EAGLE MOUNTAIN CITY
PLANNING COMMISSION MEETING AGENDA
TUESDAY, SEPTEMBER 13TH, 2016 AT 6:00 P.M.
Eagle Mountain City Council Chambers; 1650 E. Stagecoach Run, Eagle Mountain, UT 84005

EAGLE MOUNTAIN CITY
Planning Commission Staff Report
SEPTEMBER 13, 2016

Project: **Spring Run MDP Amendment**
Applicant: Jim Allred/Ralph Johnson – 12 Horse Ranch LLC
Request: Master Development Plan Amendment
Type of Action: Action Item - Recommendation to City Council, Public Hearing

Project: Scenic Mountain
Applicant: Dylan Young
Request: Master Development Plan Amendment
Type of Action: Public Hearing, Action Item: Recommendation to City Council

Figure 2 – Approved MDP

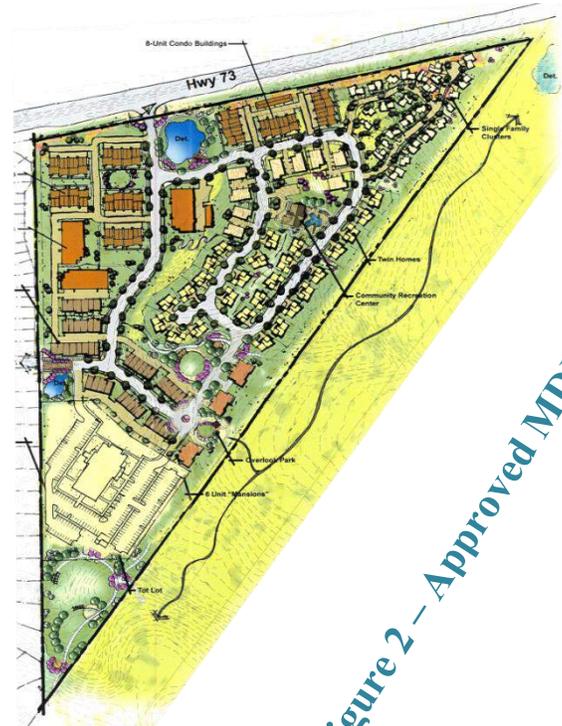
In addition to planning for the expansion of SR-73 the applicant has indicated that their desire to amend the Master Development Plan stems from a lack of flexibility within the currently approved MDA/MDP. The applicant's proposal realigns major roads within the development, and creates two vague development pods.

It should be Noted that under the approved MDP only 28 acres of property was vested with residential density, under the applicant's plan 34.82 acres of property is vested, including 6.32 acres of unbuildable property.

Setbacks: The applicant is proposing the following setback details for Cluster Lots:

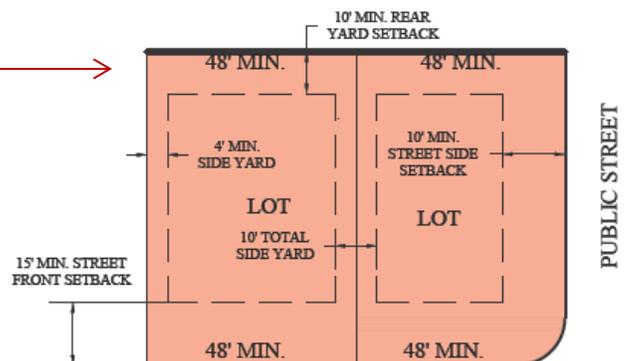
- 15 foot front yard setback
- 10 foot rear yard setback
- 4 foot side yard setbacks with a minimum of 10 feet between buildings (e.g. if lot A has a side yard setback of 4' lot B must have a side yard setback of at least 6' to maintain 10' between structures)
- 10 foot street side, side yard setback.

The proposed setbacks do not comply with Standard Tier III single family setbacks which are included below:

POSSIBLE UDOT ACQUISITION FOR SR 73 EXPANSION - 7.15 ACRES*

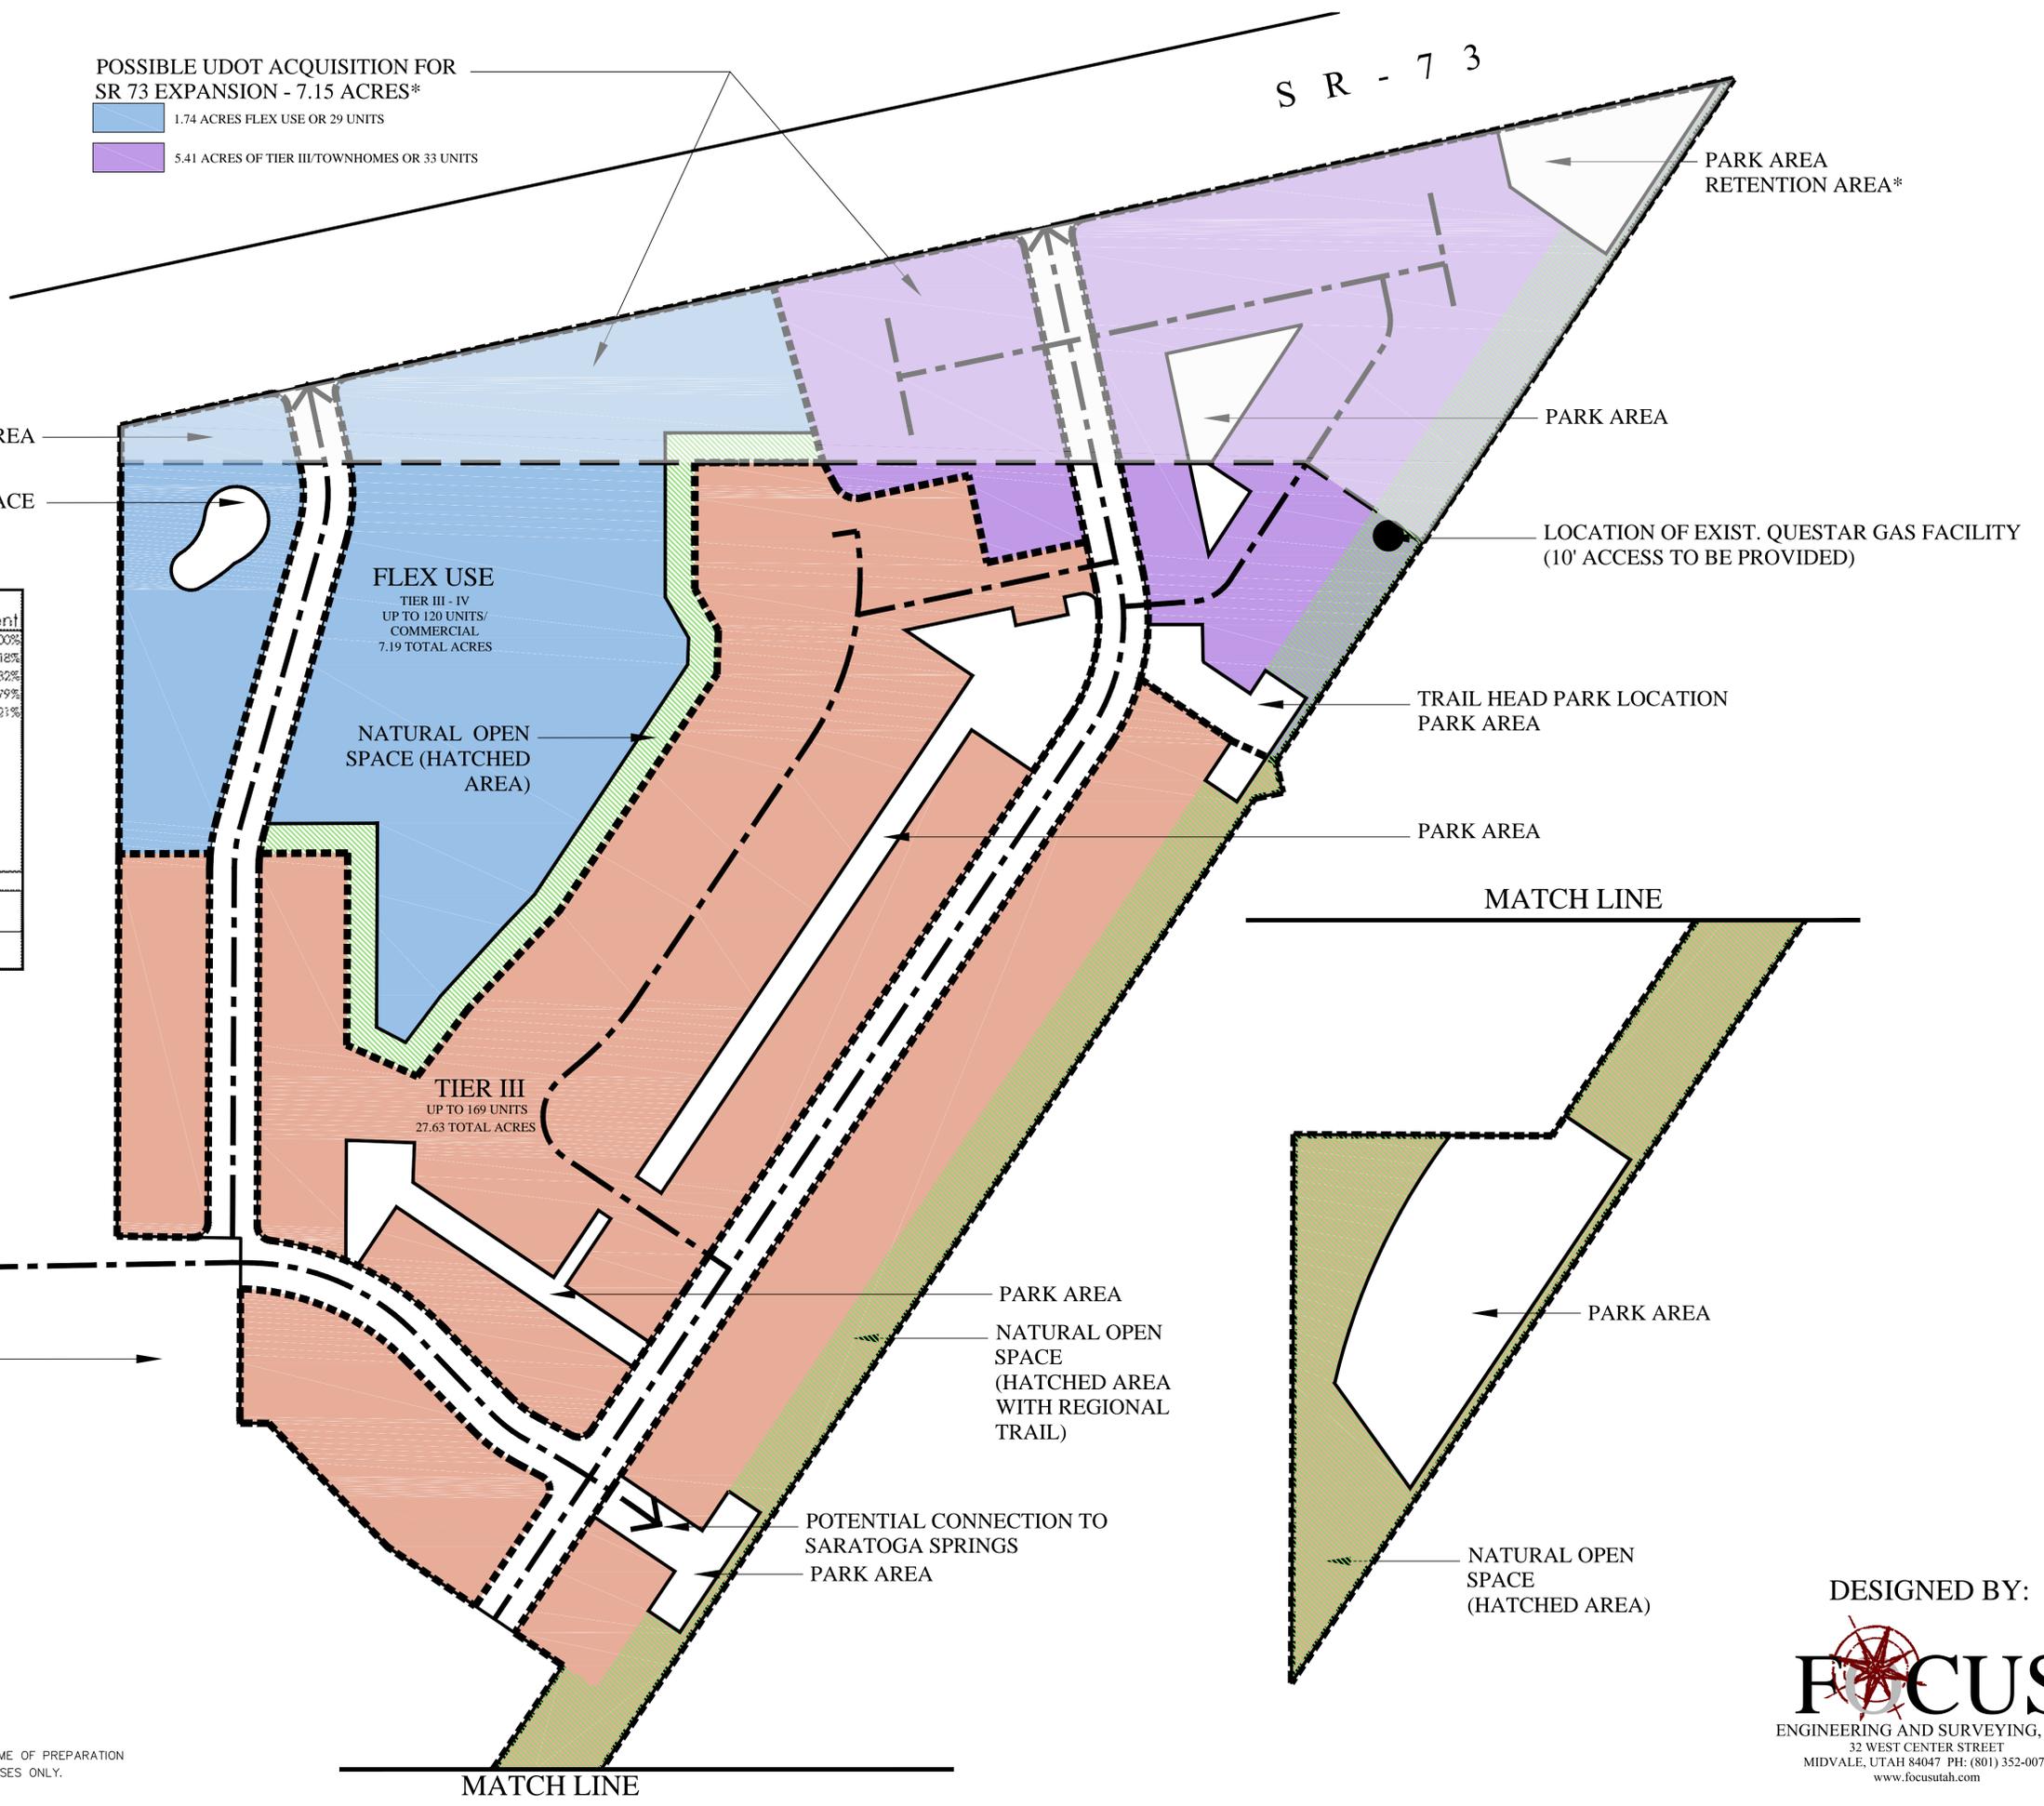
A large portion of the project is expected to be affected by the planned expansion of SR-73. The applicant has been in contact with UDOT, and it is believed that 7.15 acres of property within the Scenic Mountain Master Development Plan will be acquired to facilitate road expansion.

Staff recommends that the number of townhomes within the Tier III pod be limited to a maximum of 61 townhome units as that is the number shown in the concept plan.

- 1. Vested Density within the UDOT expansion area may not be transferred to the rest of the project*
- 2. A note shall be added limiting the maximum number of townhome units within the Tier III pod to 61 units*
